E4360A-02A

Information Only Service Note

E4360A - Modular Solar Array Simulator

Different Color Front Panel LCD Display

Blue/white Front Panel LCD Display (below) has been obsoleted.

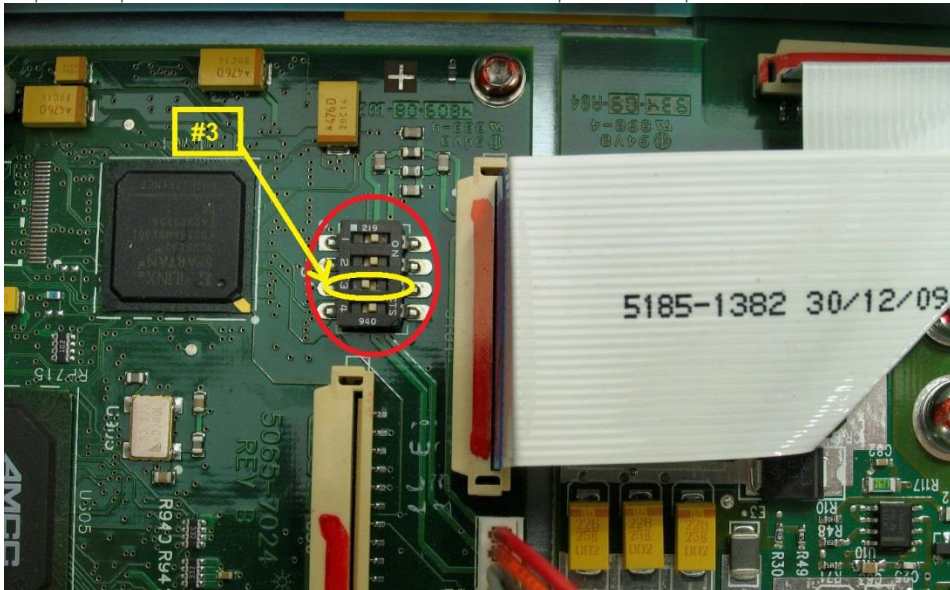
LCD (blue/white display assembly, part no. 2090-1031) has been discontinued by vendor. Replacement assembly (pictured later) is part no. 5067-5993 (amber in color). Difference in color doesn't impact any performance and specification. Unfortunately, this cannot be altered.

- 1) New LCD display (5067-5993) is a mechanical & functional “drop-in” replacement for the original.

- 2) 4-pole dip switch on PPMC PCA must have pole #3 repositioned to “off” as shown below:

- 3) Instrument firmware must be version A.02.01 or newer for proper operation of this display.
